REV. NO.	DATE	REVISIONS PRIOR TO APPROVAL
6	8/29/19	New fence on east property line Changed dim. and location of trash corral
5	8/29/19	Remove planter box, extend patio concrete and add bench detail
4	5/31/19	Added 5 handicap spaces (in lieu of the ex. 2 parallel spaces
3	6/28/17	Addressed Plan. Comm. Comments
2	6/15/17	Addressed Plan. Comm. Comments
1	5/25/17	Addressed Plan. Comm. Comments

MILLER COMMERCIAL PROPERTY
SITE PLAN
121 & 203 EAST MAIN STREET
TAX ID: 03-136094 & 03-136108
TOWN OF MIDDLETOWN
MIDDLETOWN ELECTION DISTRICT 3
FREDERICK COUNTY, MARYLAND

PROPERTY LINE FENCE AND TRASH ENCLOSURE DETAIL

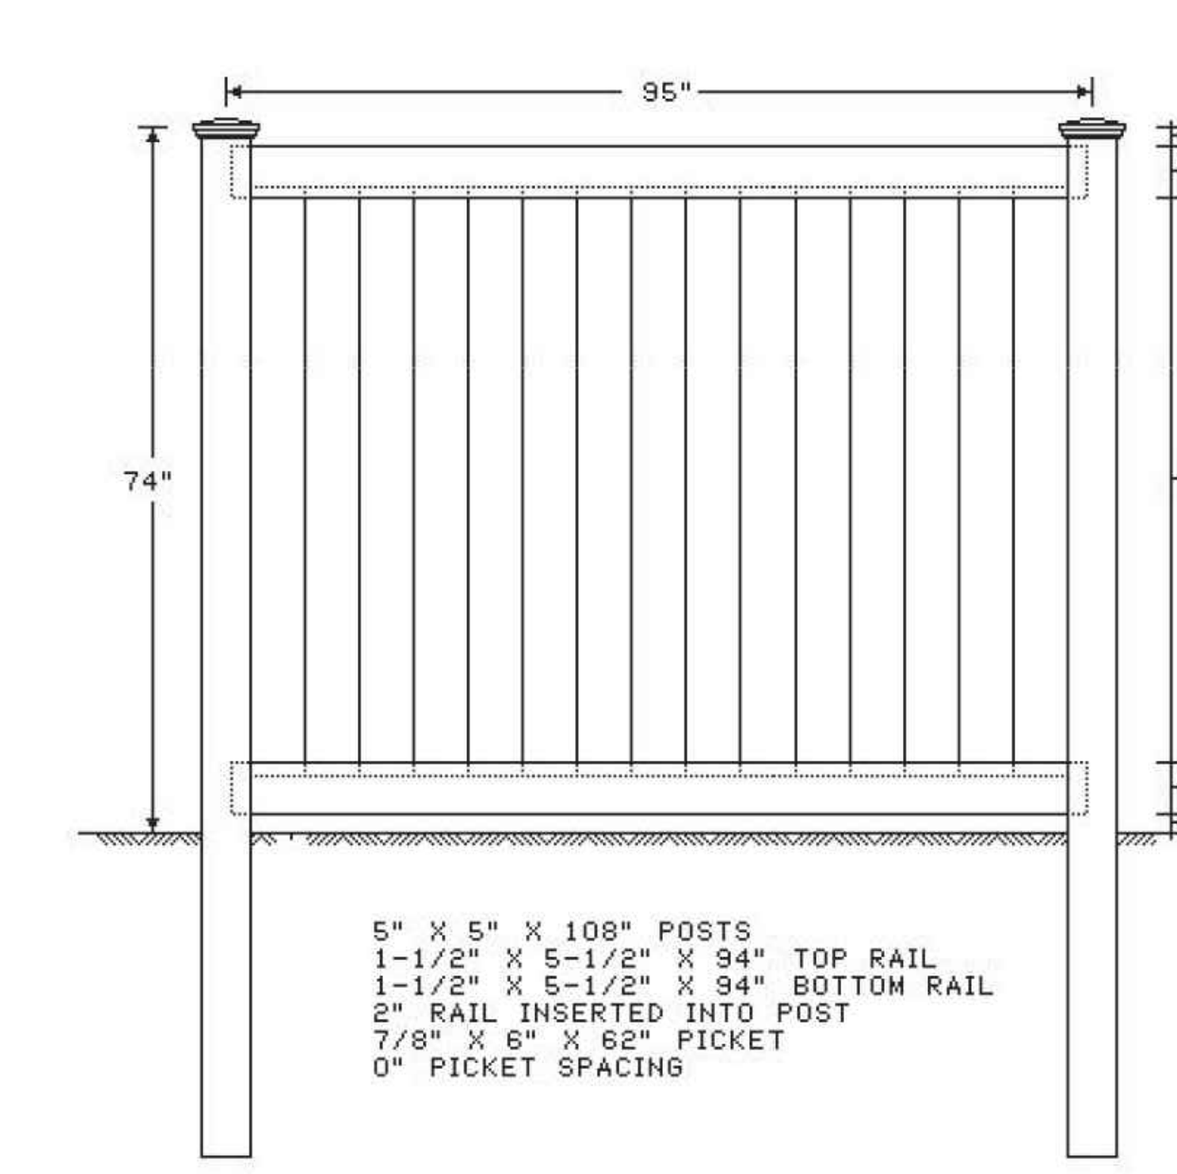
Property line fence detail to be wood
Trash enclosure material to be PVC (Color Gray)

REV. NO.	DATE	REVISIONS PRIOR TO APPROVAL
1	5/25/17	Addressed Plan. Comm. Comments
2	6/15/17	Addressed Plan. Comm. Comments
3	6/28/17	Addressed Plan. Comm. Comments
4	8/29/19	Added Fence and Trash Enclosure Detail

TRENCH DRAIN SECTION DETAIL (NTS)

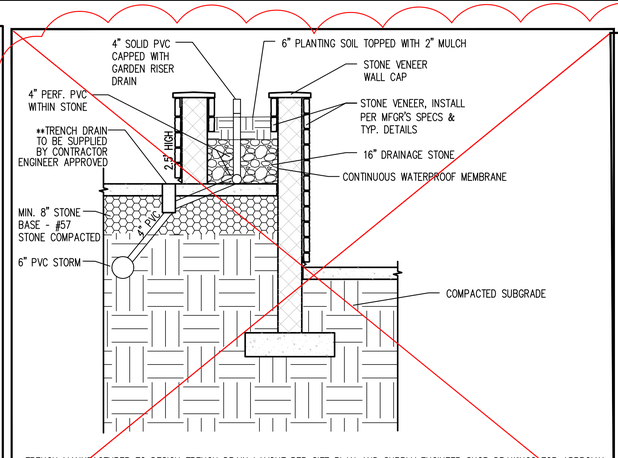
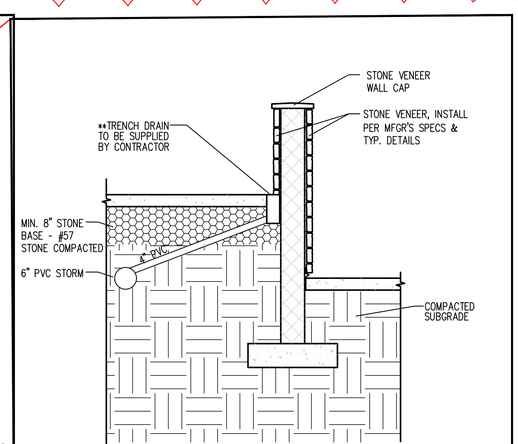
REV.	DATE	REVISIONS PRIOR TO APPROVAL
5	8/29/19	Remove planter box, extend patio concrete and add trench drain
4	4/30/18	Added X-ings to SWM Profile
3	6/28/17	Addressed Plan. Comm. Comments
2	6/15/17	Addressed Plan. Comm. Comments
1	5/25/17	Addressed Plan. Comm. Comments

**TRENCH MANUFACTURER TO DESIGN TRENCH DRAIN LAYOUT PER SITE PLAN AND SUPPLY ENGINEER SHOP DRAWINGS FOR APPROVAL

PLAN NO.: LT-1
SCALE: AS NOTED
DATE: 07/25/2017
SHEET 1 OF 2
FILE NO: 13-005

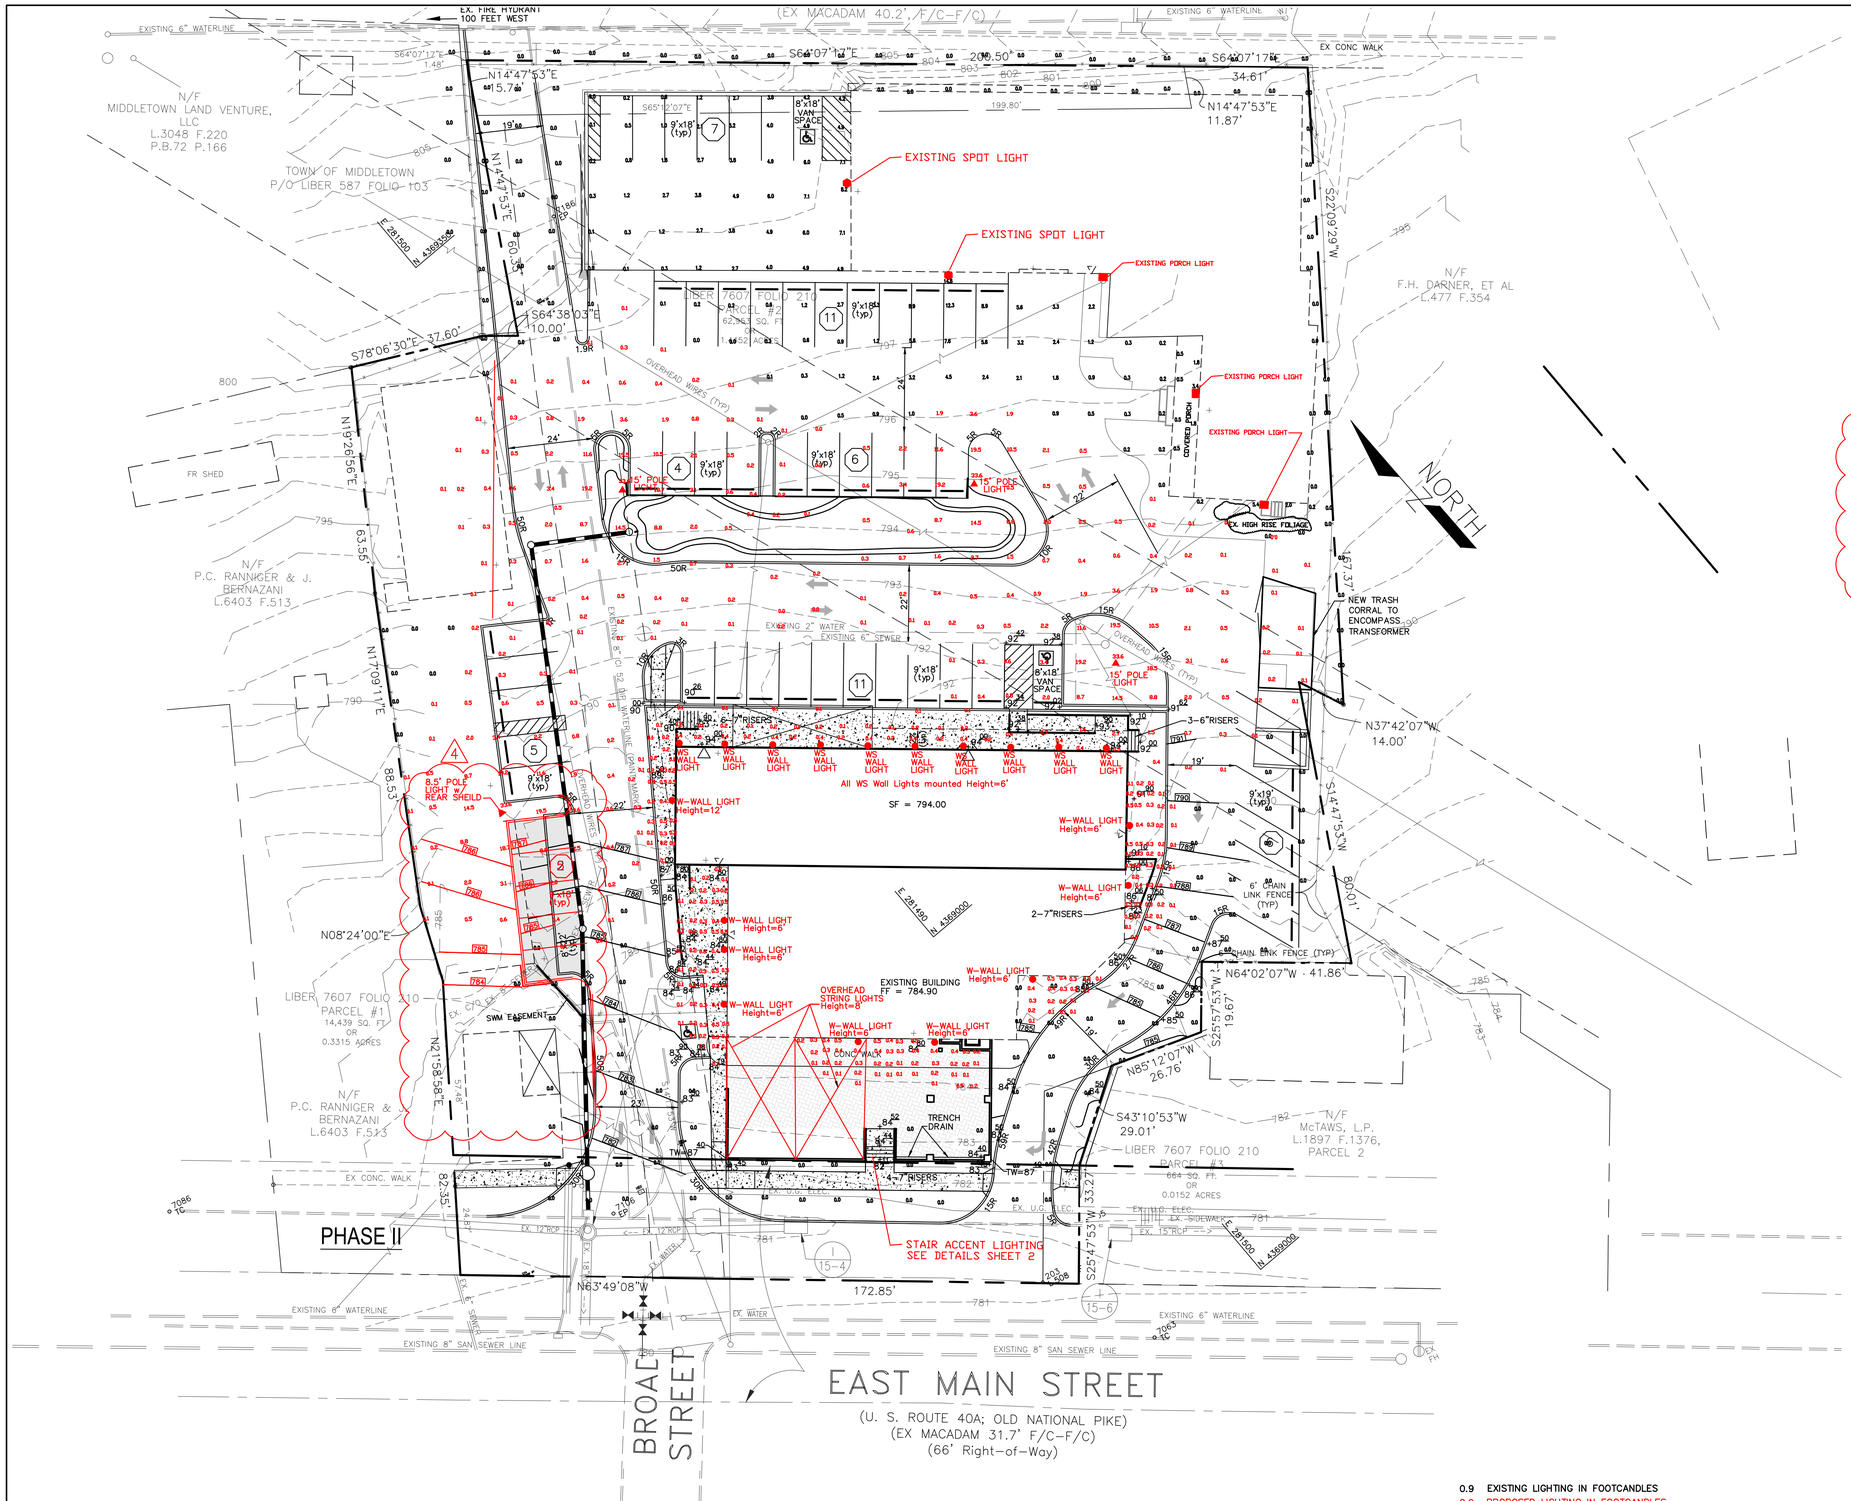
Revisions include:

1. Changing of type & pole height of parking lot poles in area of stormwater facility from 8' to 15'.
2. Changed type of parking lot pole lightS
3. Addition of 15' pole light in island at northeastern corner of building.
4. Wall lights changed from "goose neck" type to a low profile wall light
5. Addition of wall lights around side and front doorways
6. Addition of string lights over the patio
